**Subject:** Draft SRS Responses to Regulatory Comments to the FDEs for buildings 484-4D, 484-12D, 484-7D, 683-D, 454-D, 484-13D, and 484-15D  
**Date:** Tuesday, February 25, 2020 4:49:00 PM

**Draft SRS Responses to U.S. Environmental Protection Agency  
Comments on the Facility Decommissioning Evaluations for the  
Facility Decommissioning Evaluations for Building 484-4D, Powerhouse Maintenance Facility  
(G-FDE-D-00037, Revision 0, November 13, 2019), Building 484-12D, D-Area Storage Building  
(G-FDE-D-00038, Revision 0, November 18, 2019), Building 484-7D, D-Area Storage Building  
(G-FDE-D-00039, Revision 0, November 13, 2019), Building 683-D, Chlorine Unloading and  
Storage (G-FDE-D-00040, Revision 0, November 13, 2019), Building 454-D, D-Area Diesel Fuel  
Tank (G-FDE-D-00041, Revision 0, November 13, 2019), Building 484-13D, D-Area Storage  
Building (G-FDE-D-00042, Revision 0, November 18, 2019), and Building 484-15D, D-Area  
Storage Building (G-FDE-D-00043, Revision 0, November 18, 2019) Simple Model  
Comments Received on 2/11/2020**

Figure 1. D-Area Aerial Overview

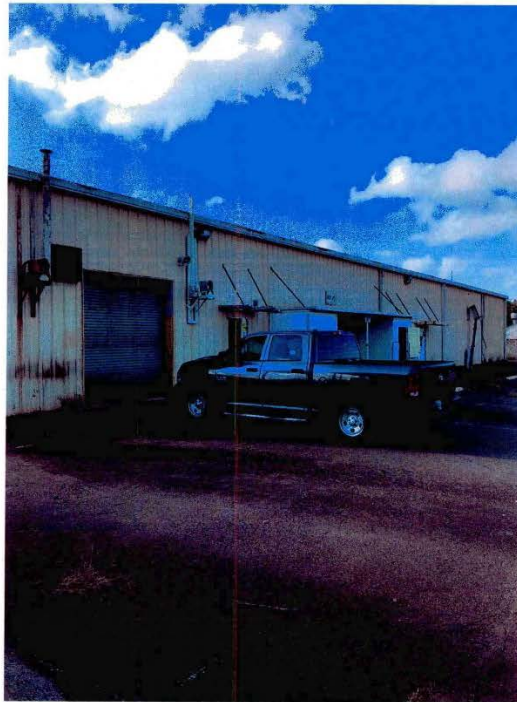
- 3) Please provide one figure that depicts the relationship between the 7 buildings and their ancillary structures

**Response. Agree. Figure 1, D-Area Aerial Overview, shows the FDE buildings and their relationship to the 484-D Powerhouse, the D-Area Boiler and Process Water Treatment Facility, and the 115 KV SCE&G Sub-Station. No change to FDE is proposed.**
